Re: Development Application No. DA2021-0024, 124 Forest Road Hurstville

SJB Planning was requested to provide an independent peer review of the subject DA and proposed amendments in relation to the following urban design issues raised in Council's correspondence of 14 May 2021:

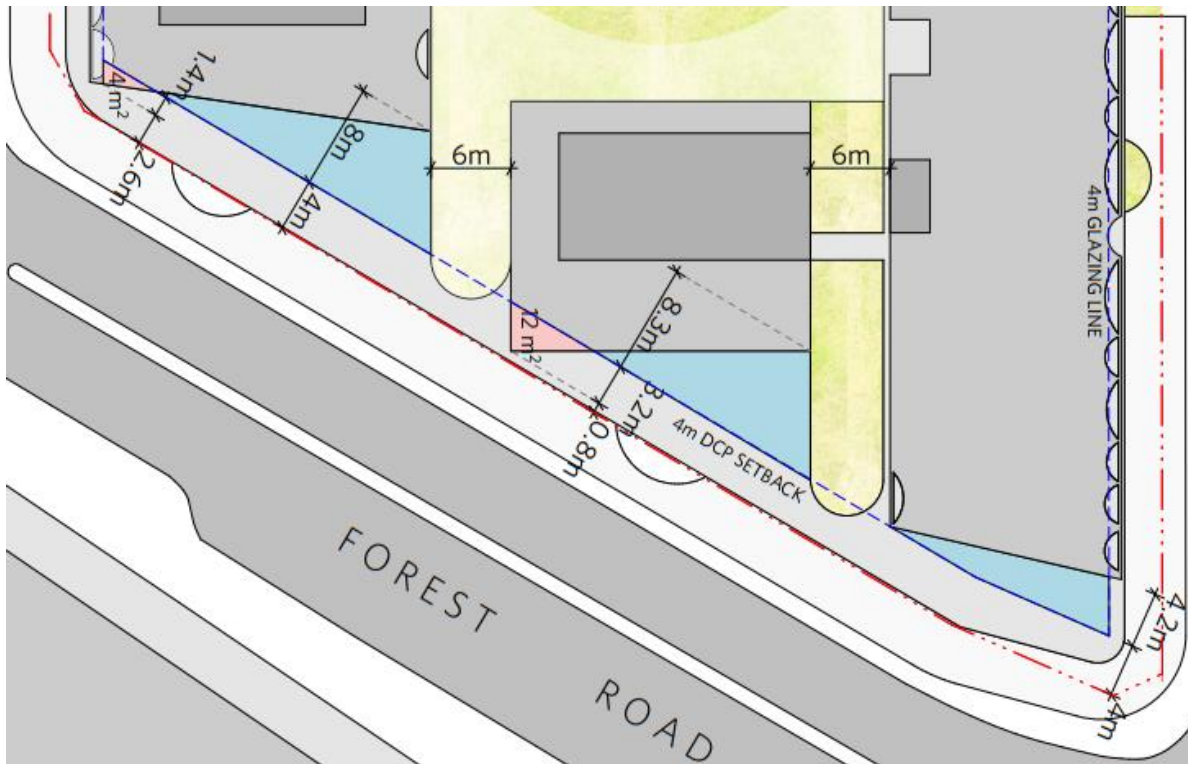
HDCP No. 2 - The upper level setback to Forest Road breaches the minimum 4m on the corner of Forest Road and Hudson Street

The proposed tower form presents a staggered building alignment to Forest Rd with a portion of the footprint area encroaching into the required upper-level setback zone. We recommend realigning the towers to address Forest Rd and street corners to achieve a more harmonious fit to the context.

The following diagram prepared by DBJ illustrates the minor nature of the encroachment into the 4m tower setback applying to Forest Road. The encroachments are represented by the pink shading and are described below:

- A small portion of the south-western edge of Building A tower encroaches into the 4m setback by 1.4m at the corner with Hudson Street; and
- The corner of the central tower of Building B tower encroaches into the 4m setback by 3.2m, towards the centre of the site.

The encroachments are negligible and will be indiscernible given the towers are predominantly setback in excess of 4m. Tower A is setback up to 12m and the two towers forms of Building B have maximum setbacks of 8.2m and 12.3m. In this regard, the alignment of the proposed towers to Forest Road provides a larger setback on average than the minimum 4m setback required by the HDCP No. 2.
